**IMPERIAL METALS CORPORATION
MT. POLLEY PROJECT**

**RESPONSE TO REVIEW COMMENTS
ON TAILINGS EMBANKMENT DESIGN
(REF. NO. 1625/6)**

JANUARY 25, 1996

FIGURE 1

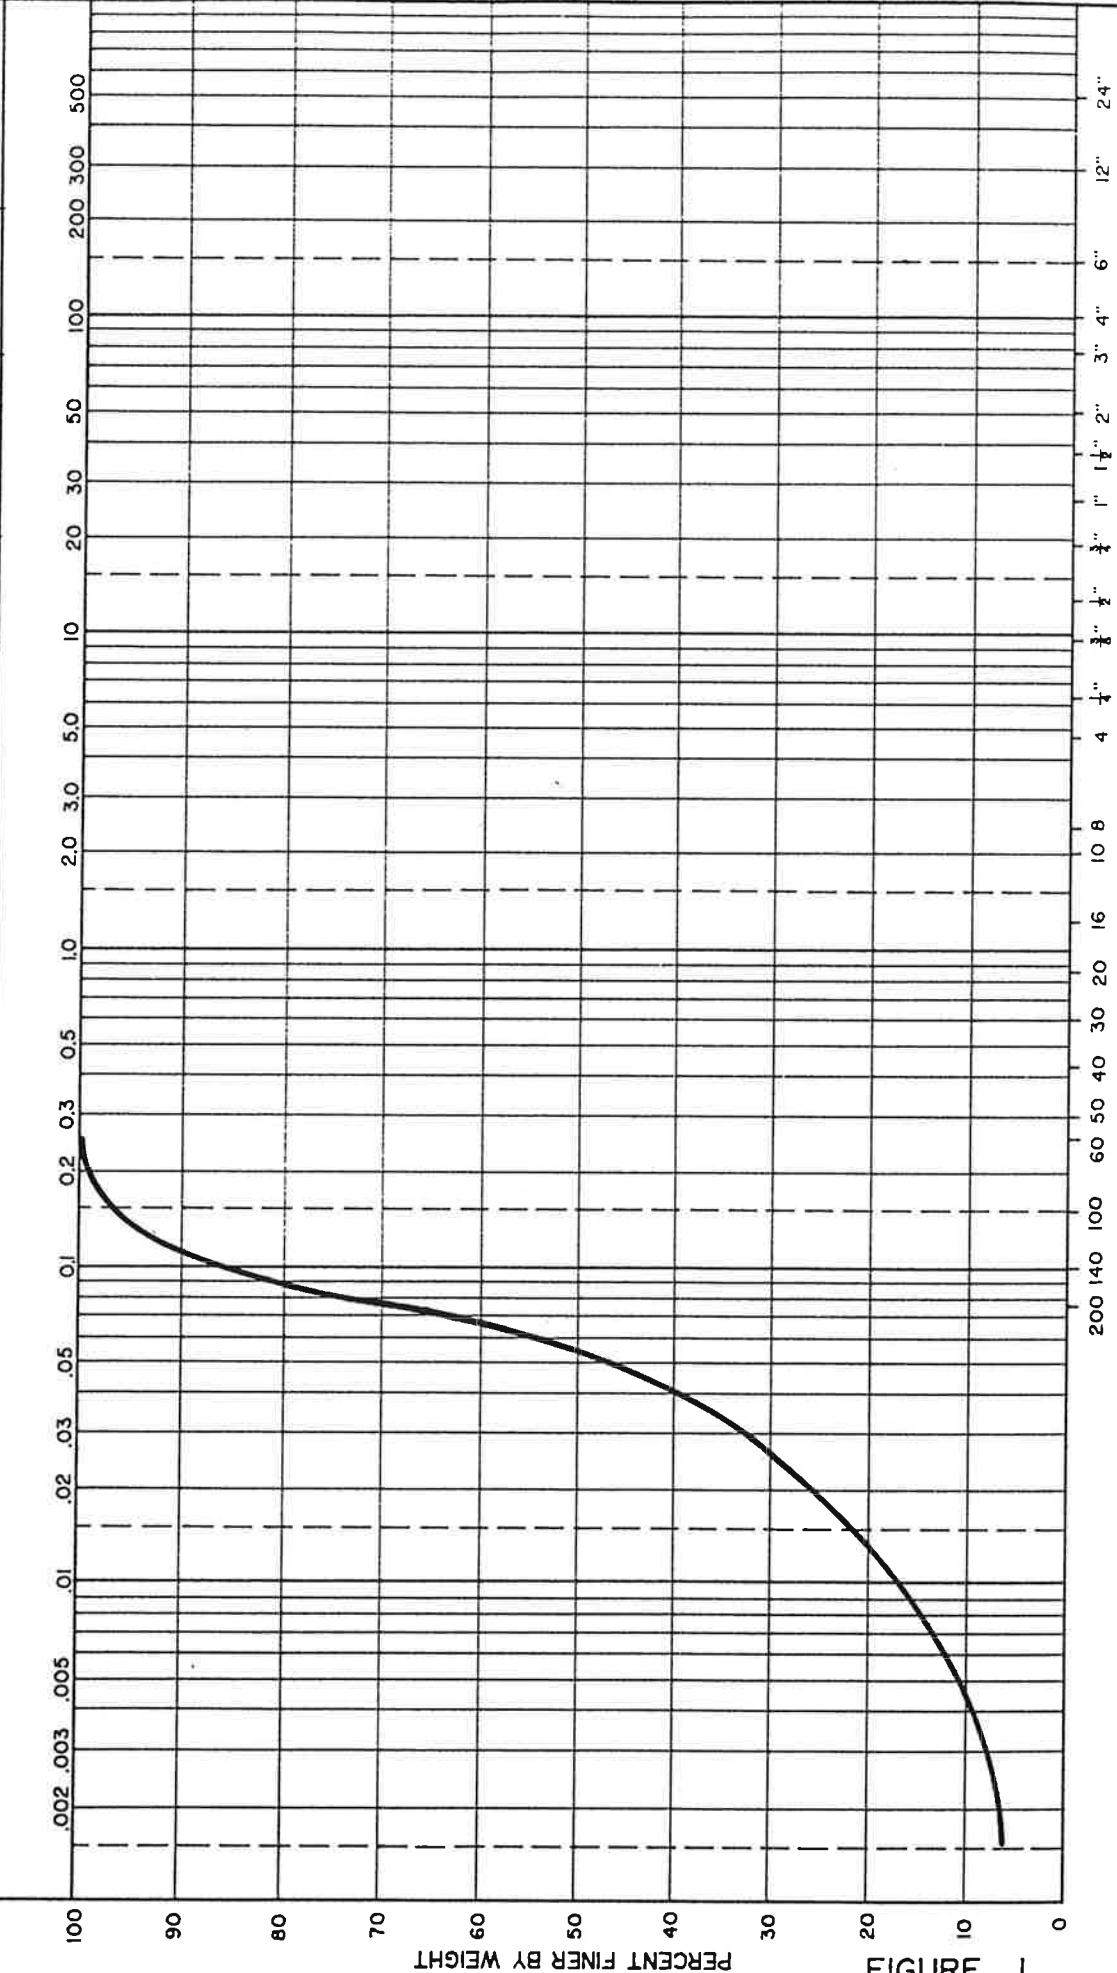
Filter gradation is required to be shown. The design must be conservative.

Filter gradations for construction materials are shown on Drawing No. 510-14-03-1625.212, which is taken from part of the Technical Specifications. The gradation of the tailings is shown on Figure 1 (from Tailings Storage Facility Design Report, Ref. No. 1625/1, May 26, 1995).

Index tests on the bulk tailings sample shown on Figure 1 indicate that the material is non-plastic and fine grained, with 6 percent clay, 64 percent silt and 30 percent fine sand. The operations of the tailings spigotting system will lead to some separation of the tailings adjacent to the embankment, whereby coarser materials will settle out rapidly and finer materials will be transported further out into the pond. The result is that additional filter relationships will be developed between the fine and coarse tailings as well as between the coarser tailings and embankment fill materials. In the event that cracks develop on the embankment from the upstream side, it is anticipated that the tailings will also function as a crack stopping filter medium.

FIGURE 2

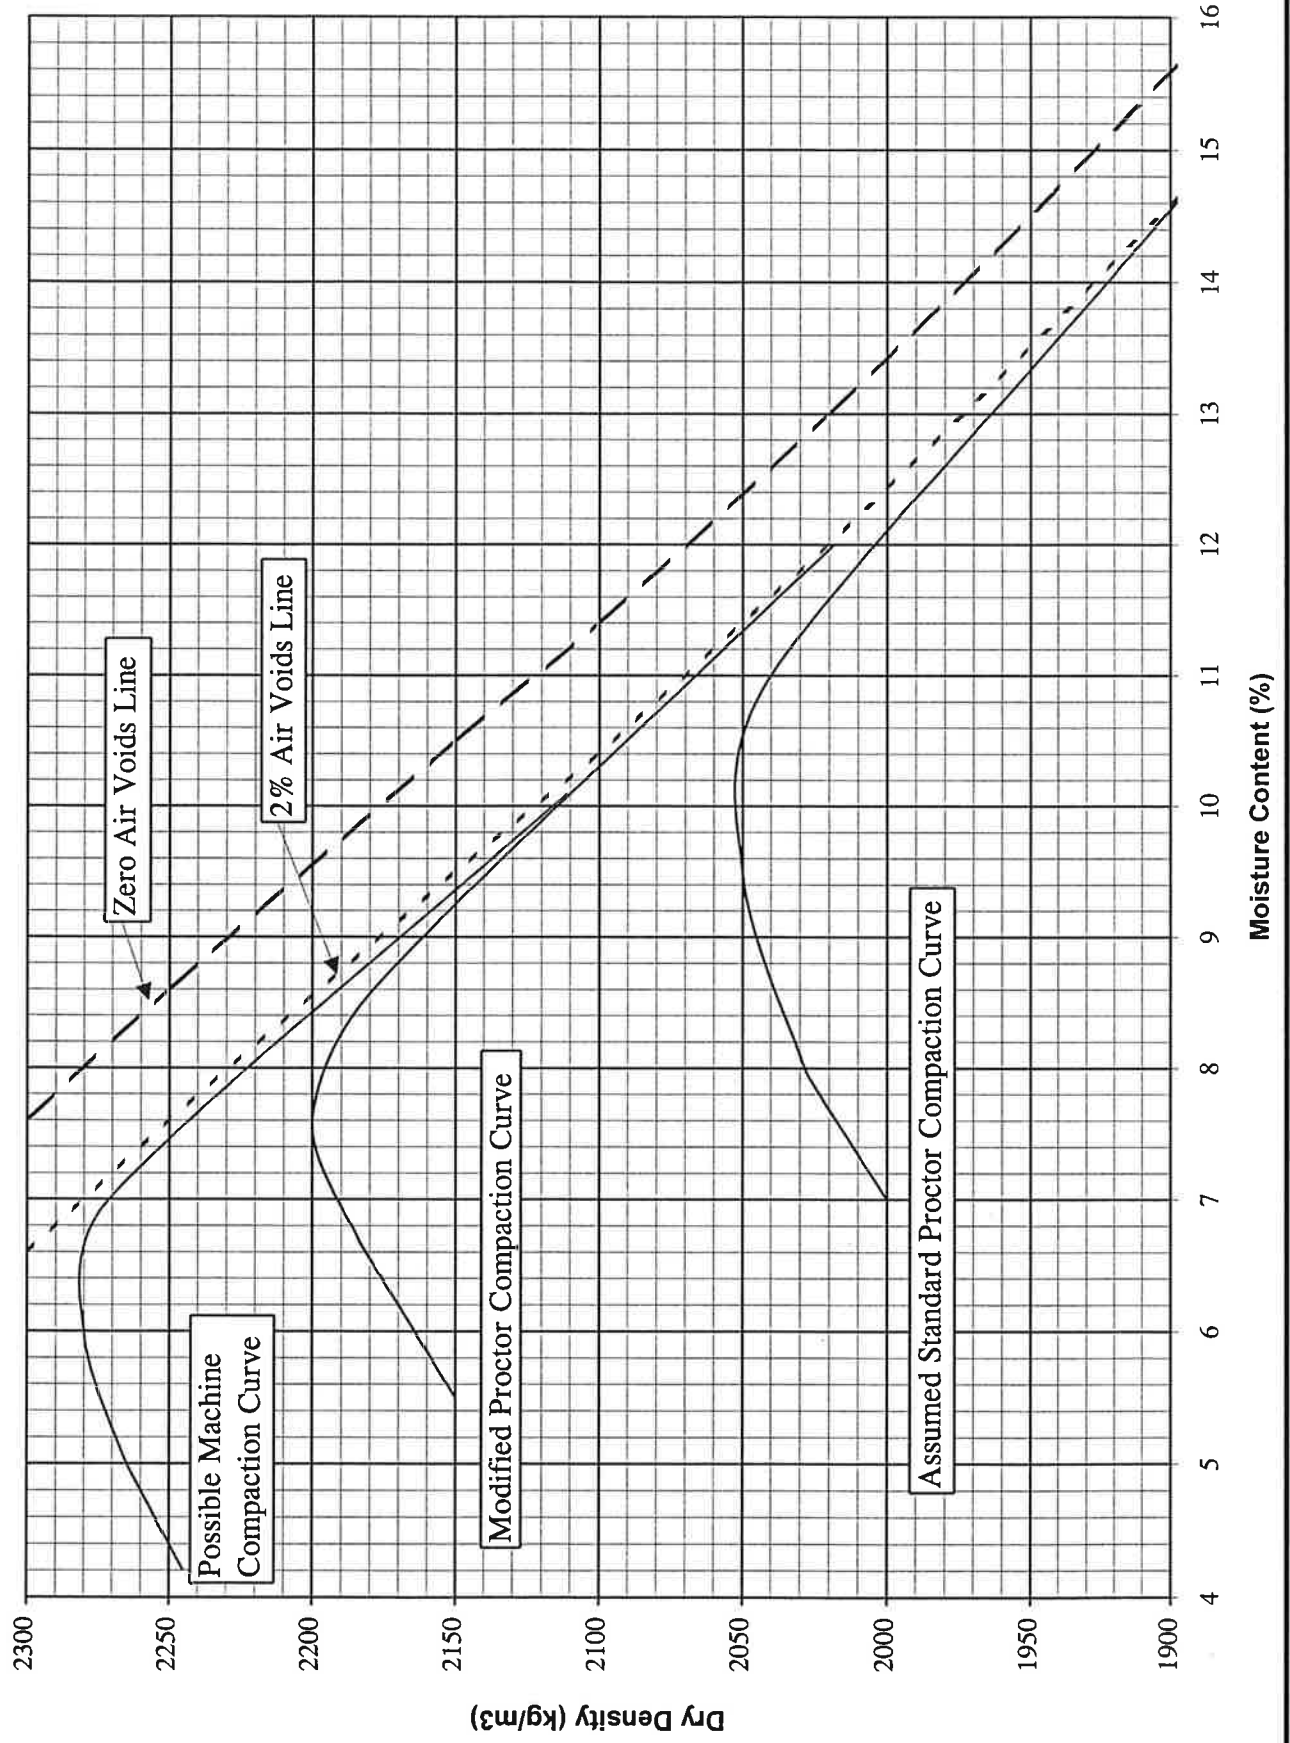
Why is Modified Proctor density used as the reference? Standard Proctor density is more common. A higher moisture content can be tolerated with Standard Proctor criteria. Over-compaction results in a brittle dam structure with limited flexibility to deal with differential settlement.

Mr. Brawner's statements reflect a common misconception within the earthworks construction industry. As indicated on Figure 1, there are different moisture-density relationships depending on the level of compactive effort applied. The Standard Proctor energy is lower than for the Modified Proctor test and, for the given example, the machine compaction energy is still higher.

It is evident from Figure 2 that if one only considers the individual test results, the 'maximum' density decreases as the compaction effort is reduced, and the 'optimum' moisture content also increases as the compactive effort is reduced. However, the theoretical moisture content - density relationship for a soil is defined by the zero air voids line, but we generally find that the 2% air voids line is usually the control in practice. Consequently, if the Standard Proctor moisture density criteria are

specified, a lower density fill with a higher permeability and greater compressibility can result. Also, if the contractor attempts to place the fill at the standard proctor optimum moisture content with the heavier compaction equipment, he will sometimes find that excessive rutting, weaving and pore pressure development (or moisture profiles) can occur in fine grained soils. Knight Piésold have therefore used the Modified Proctor test as the reference as it provides a moisture - density relationship which is closer to the relationship expected from the specified compaction equipment.
